Interactive comment on “A small volume multiplexed pumping system for automated, high frequency water chemistry measurements in volume-limited applications” by Bryan M. Maxwell et al.

Received and published: 18 July 2018

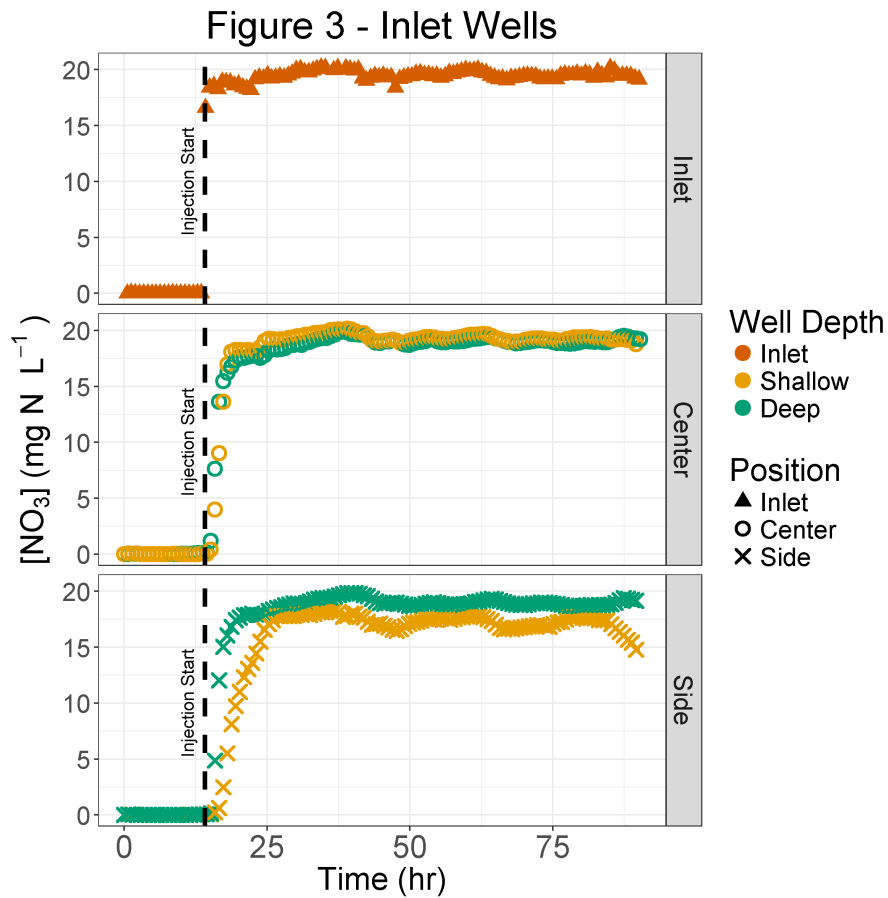
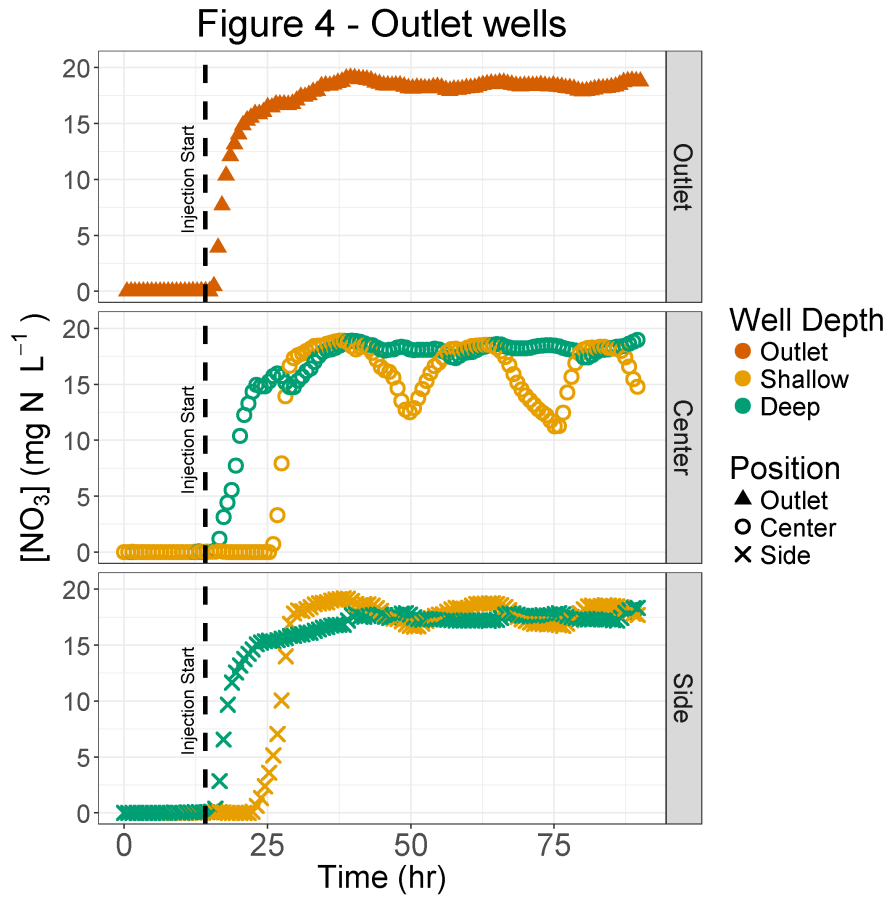
Figure 3-4: The symbols are slightly difficult to distinguish. Putting the y axis on a log scale might help.

Figures corrected to show nitrate concentrations at each well in separate panels to make points easier to distinguish, as a log scale did not help significantly for this data. See attached figure.
